Product Change Notification / LIAL-04MJOW029

CCB 6023 Final Notice: Qualification of MTAI as a new final test site for LX7167CLD-TR and LX7167ACLD-TR catalog part numbers (CPN) available in 8L WDFN (2x2x0.8mm) package.

Pre and Post Change Summary

PCN #: LIAL-04MJOW029

Carrier Tape

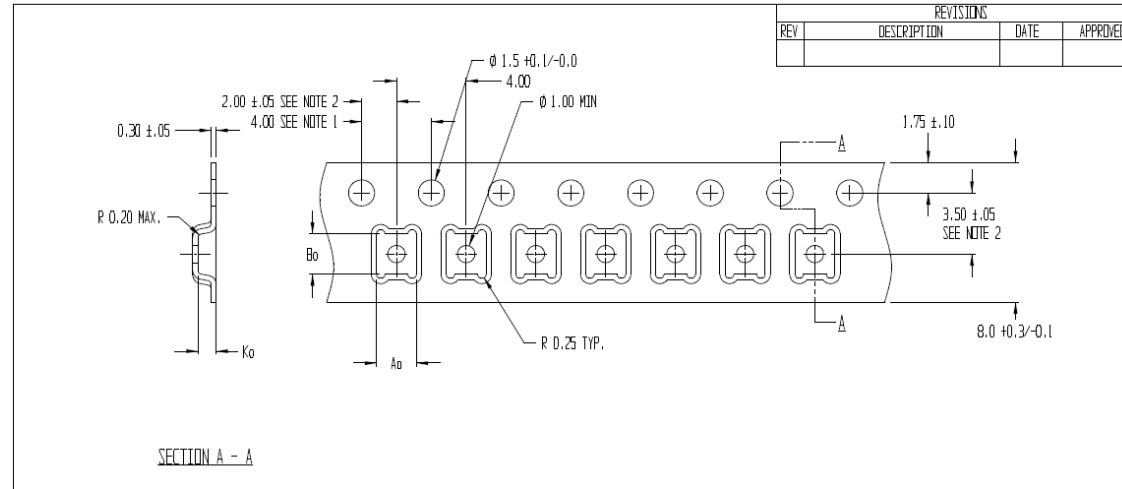
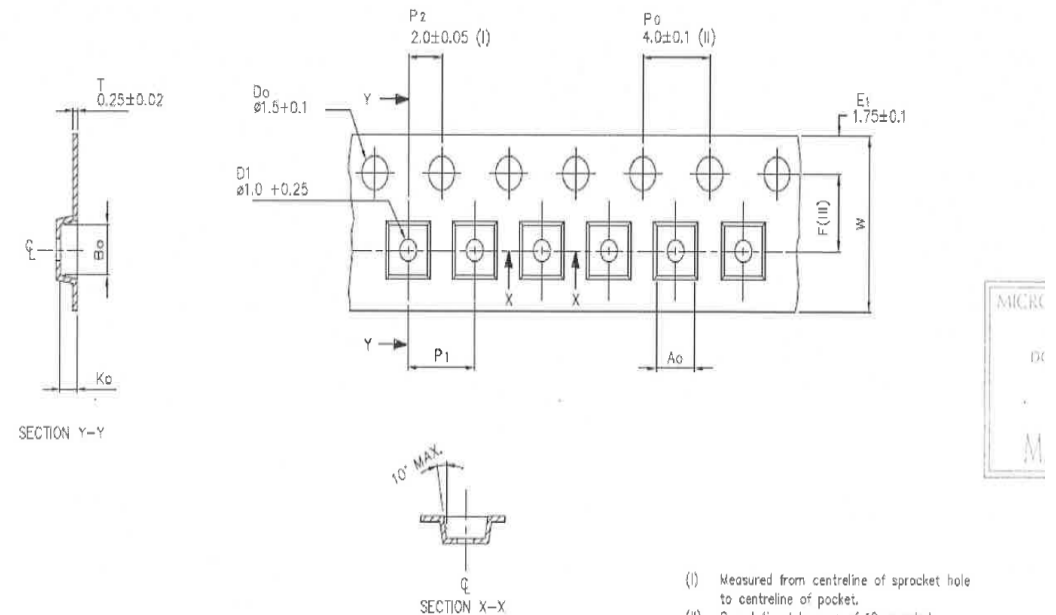
Plant	W (mm.)	P (mm.)	A0 (mm.)	B0 (mm.)	K0 (mm.)	K1 (mm.)	Thickness
UDG	8.0+0.3/-0.1	4.0±0.10	2.30 ±0.10	2.30 ±0.10	1.05 ±0.2	-	0.30 ±0.05
MTAI	8 +0.30/-0.10	4 ±0.10	2.30 ±0.05	2.30 ±0.05	1.00 ±0.05	-	0.25 ±0.02

Cover Tape

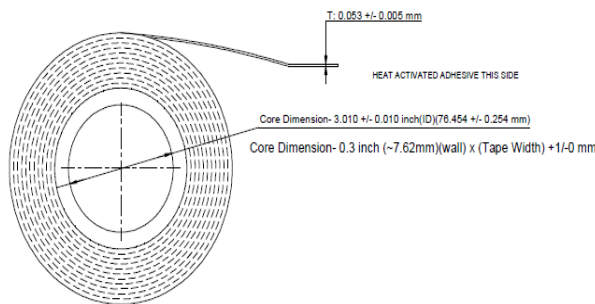
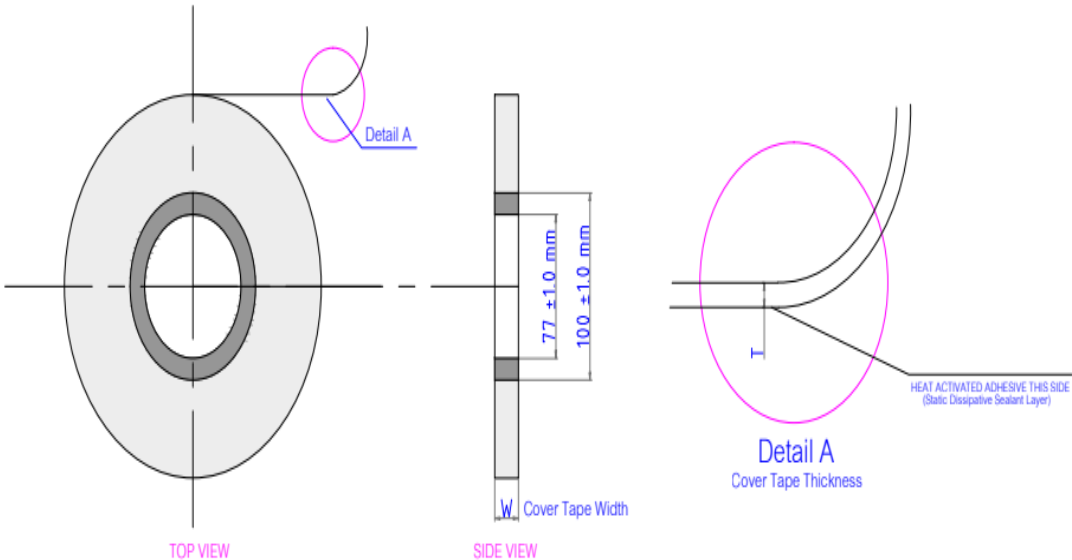
Plant	Width W (mm.)	Thickness T (mm.)	Color	Sealing Methodology
UDG	5.4±0.1	0.053 ±0.005mm	Clear	Heat sealing
MTAI	5.3 ±0.1	0.050 ±0.010mm	Clear	Heat sealing

Plastic Reel

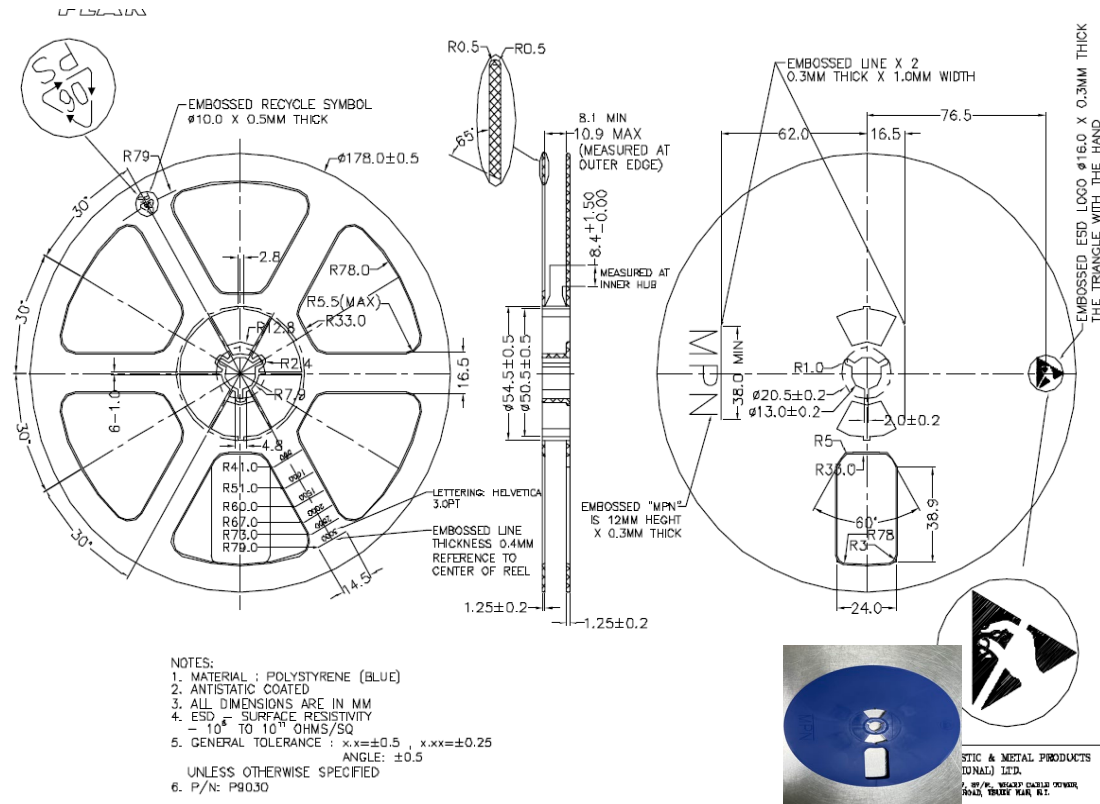
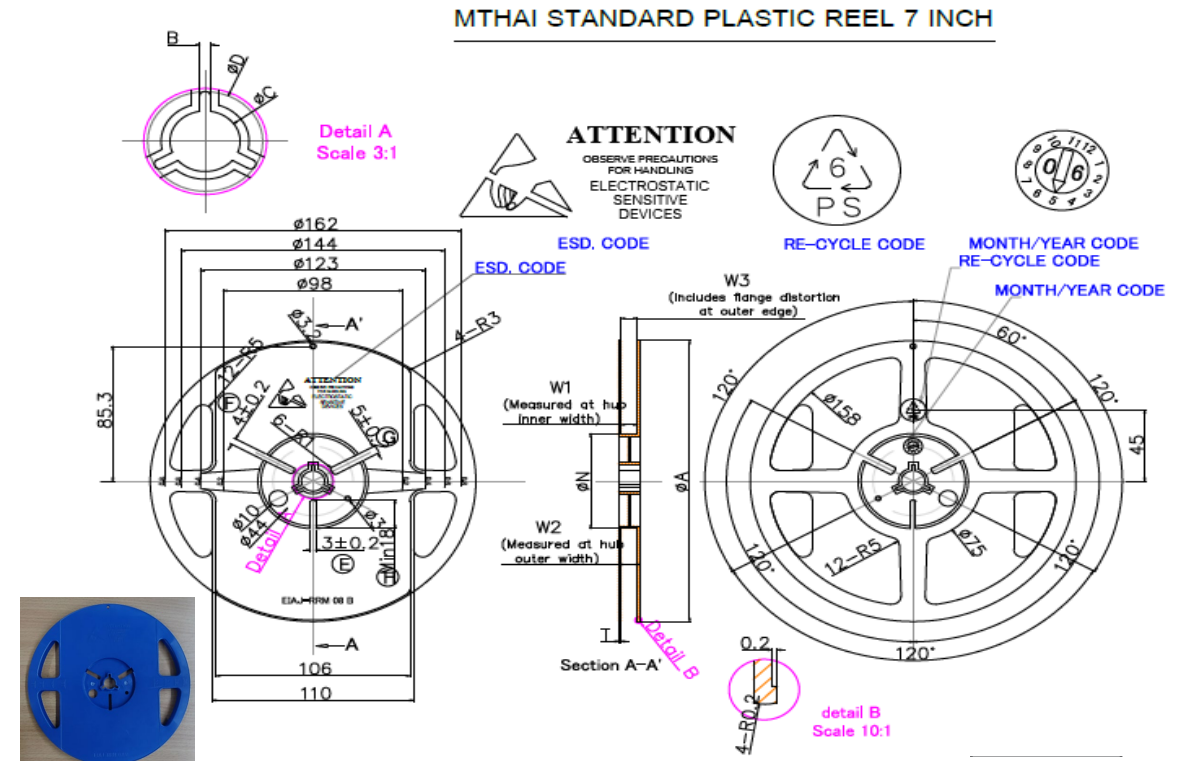
Plant	Reel Diameter (mm.)	Reel Hub Size (mm)	Reel Width Max (mm.)	Color
UDG	178.0 ± 0.5	54.5 ± 0.5	10.9	Blue
MTAI	178 ± 2.0	60.5 ± 0.50	14.40	Dark Blue
